Deferred Submittal Requirements and Application

Plan Review - All Review Comments Report

Project Name: **20-161288-DFS-01-CO**
Workflow Started: **2/25/2022 11:59:55 AM**
Report Generated: **08/02/2022 03:28 PM**

YVFWC PORTLAND CLINIC
YAKIMA VALLEY FARM WORKERS CLINIC
SE 88th Ave & SE Powell Blvd.

25 ROOF PLAN
A1.31 1/8\"/>

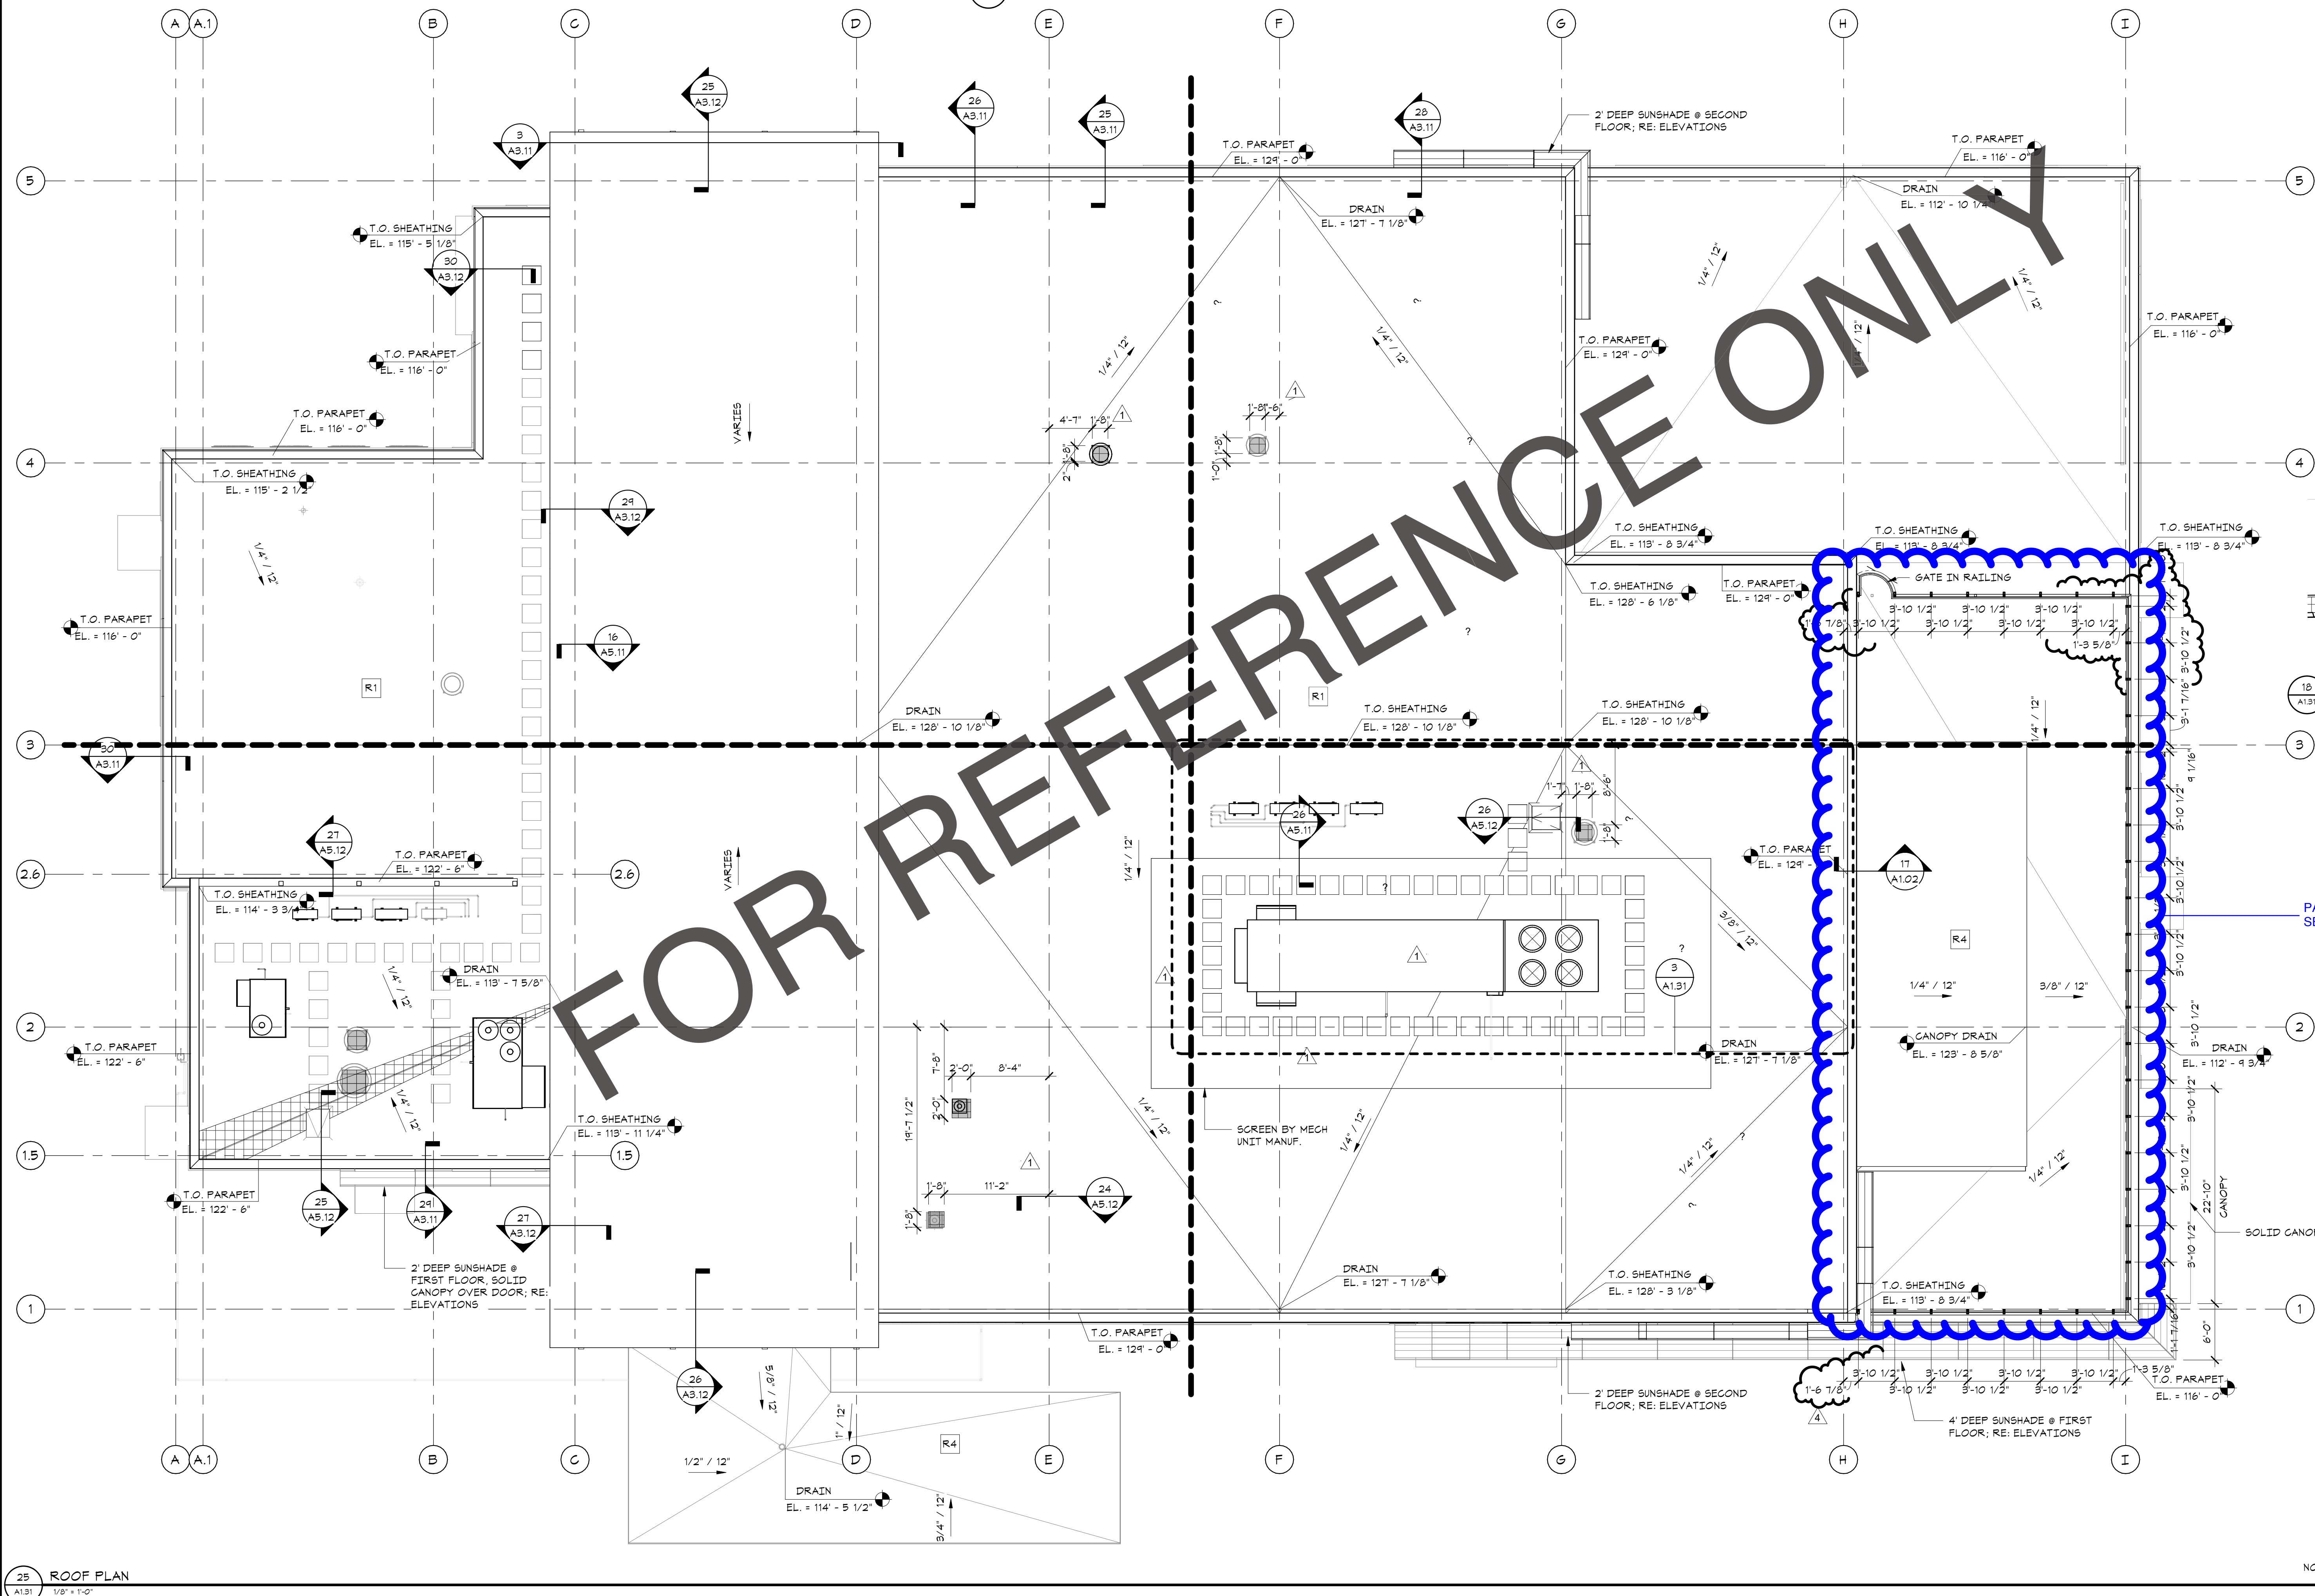
2	1		Structural David Tarries 3/8/22 2:43 PM	Changemark roof plan (OSSC 107.2.1) This partial plan may be something that could be added to the construction drawings with detail cuts provided so show the scope of this DFS. Do note that since there are walls on 4 sides of the pavers in this permit, a specific DFS for their restraint was not required. Restraint of other items on the roof not exempt per ASCE 7 13.1.4 still need to be submitted in other DFS permits. Items such as planters need to be restrained to the roof diaphragm. Using the paver system to restrain other units is not acceptable unless the paver system is engineered for that load.	999.002 Roof Paver Report and Calcs.pdf	Reviewer Response: David Tarries - 8/2/22 3:21 PM 08-02-22 - DTarries - Resolved. ----- Responded by: Walter Stern - 7/15/22 1:45 PM PEC 07/14/2022: Please see revised signed and sealed drawings and calculations.

12 COLLECTOR AT ROOF
S5.22 $3/4" = 1'-0"$

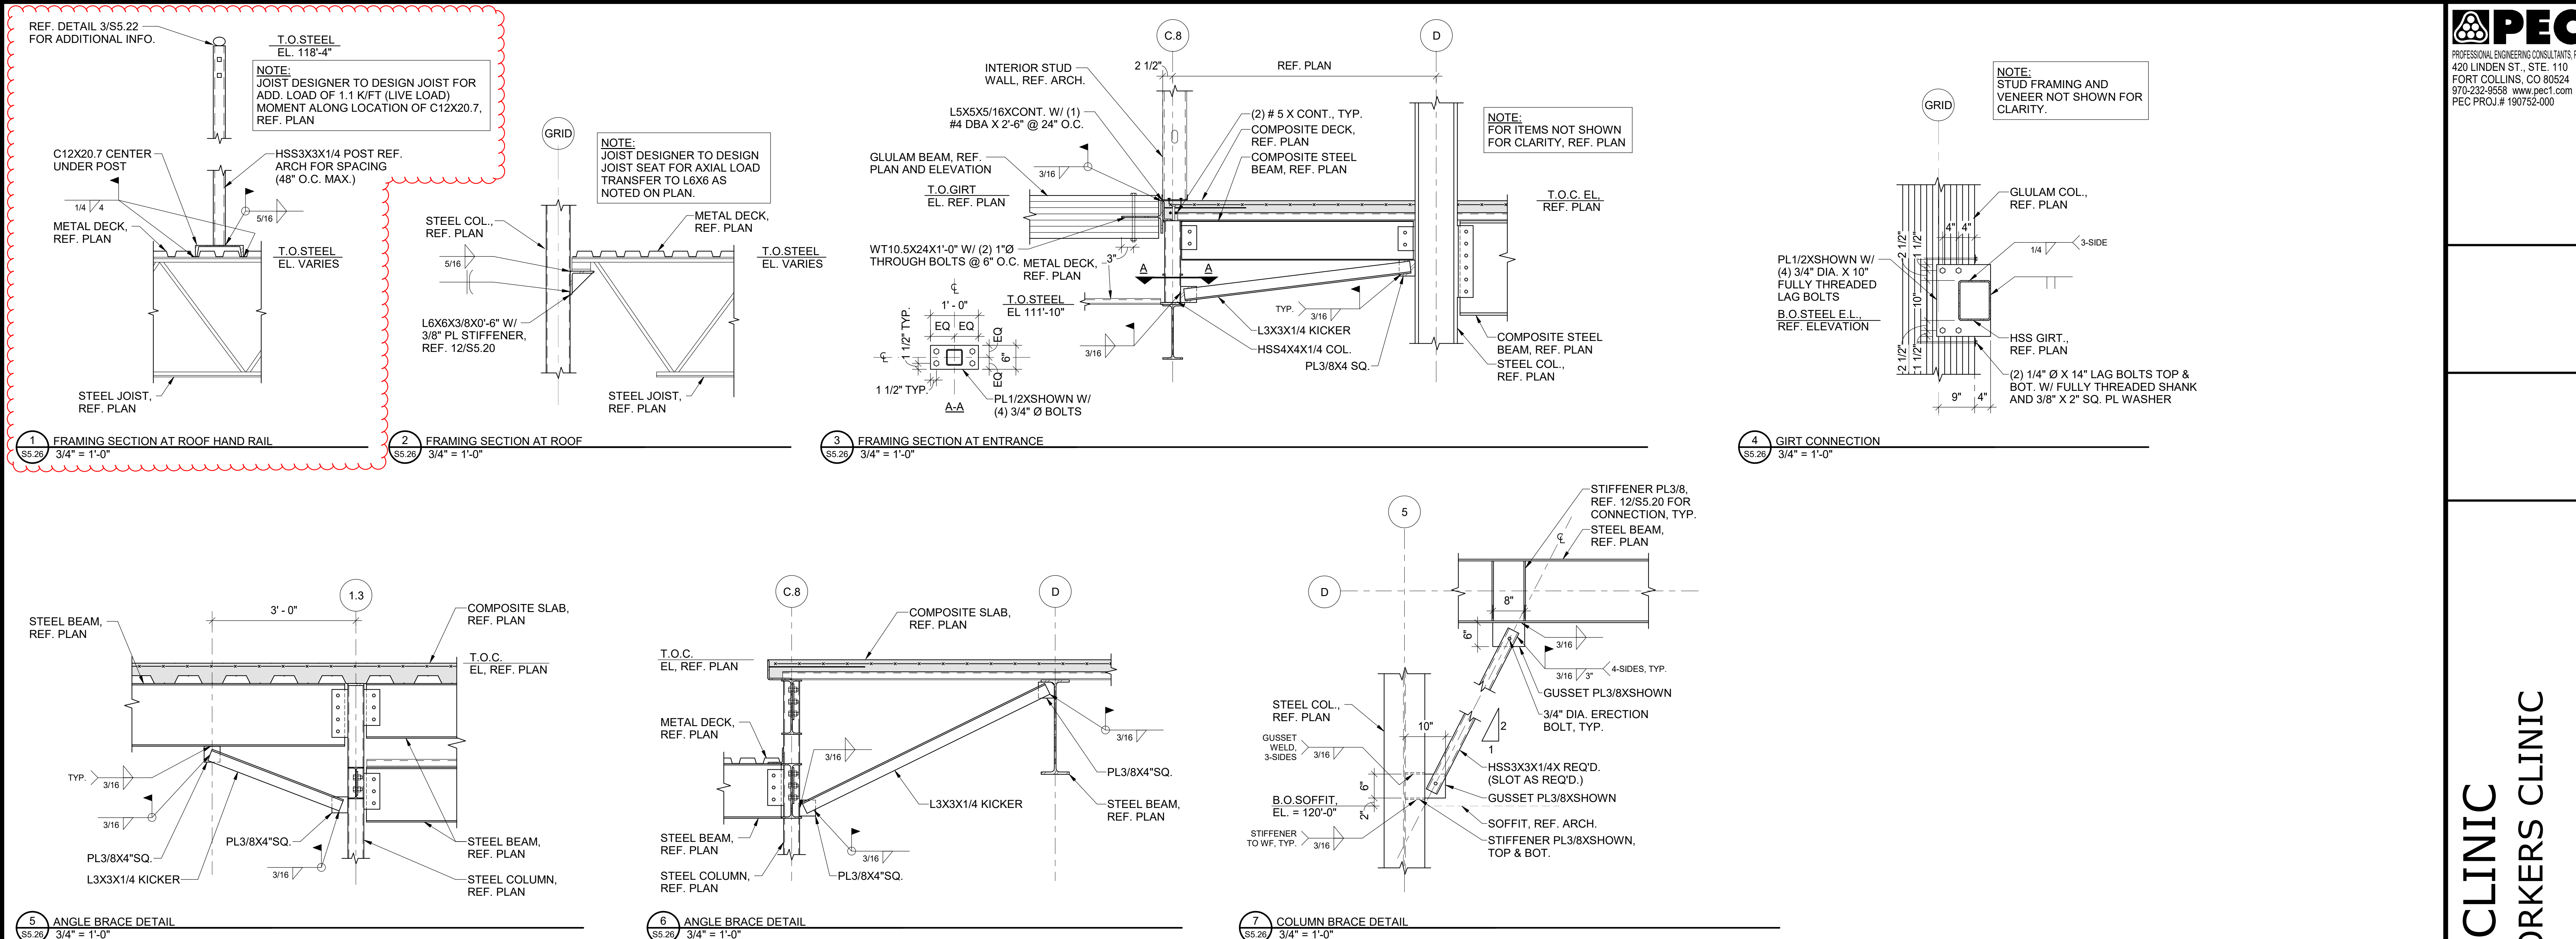
REVIEW COMMENTS						
REF #	CYCLE	DEPARTMENT	REVIEWED BY	TYPE	FILENAME	DISCUSSION
1	1		Structural David Tarries 3/8/22 2:40 PM	Changemark construction details (OSSC 107.2.1) It appears there are 4 details in this calculation package that need to be put in the drawings folder signed and sealed by a design professional. In order for a permit, DFS or otherwise, to be approved there must be construction drawings that can be stamped approved. If the additions to the existing details are to be included in this DFS instead of a REV, that is fine, but they must be signed and put in the drawings folder. It also appears that special inspection for steel needs to be listed on these drawings and there should be a clear roof plan showing where these details apply to create a complete set of construction drawings per OSSC 107.2.1. Please provide construction drawings that can be approved.	999.002 Roof Paver Report and Calcs.pdf	Reviewer Response: David Tarries - 8/2/22 3:21 PM 08-02-22 - DTarries - Resolved. ----- Responded by: Walter Stern - 7/15/22 1:45 PM PEC 07/14/2022: Please see revised signed and sealed drawings and calculations.
